## Technical Note

To: Swale Borough Council  
From: Iceni Projects Ltd  
Date: 20.01.2020  
Title: Land at Stones Farm, Bapchild, Kent

### LAND AT STONES FARM, BAPCHILD, KENT – TECHNICAL NOTE

Figure 1 – Potential Error in Car Parking Space

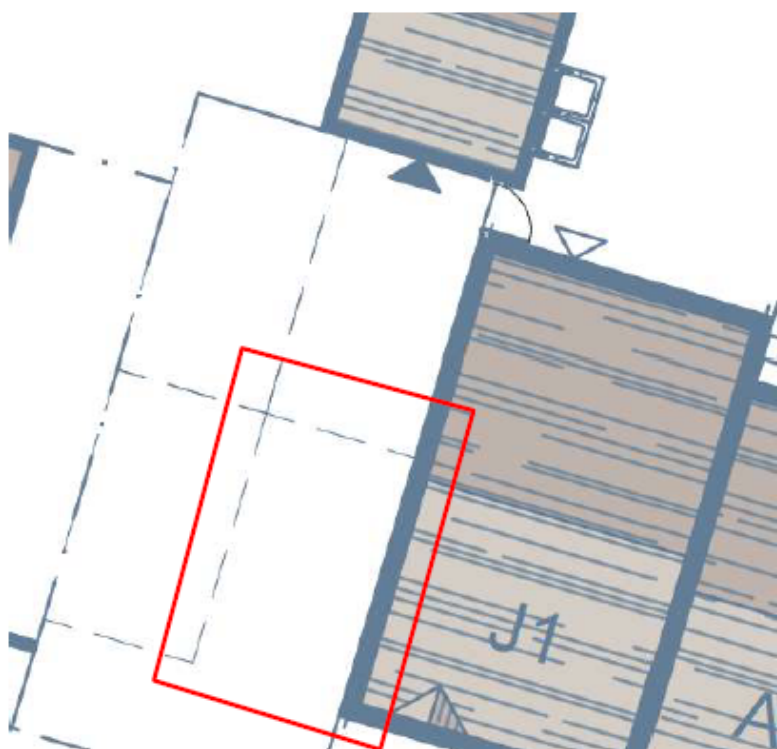
13. It is pertinent to note that there are four occasions across the site where there appears to be a line missing as shown below in Figure 1. These have not been included within the overall provision and therefore need to be reviewed further, and in reality provide an additional one space.
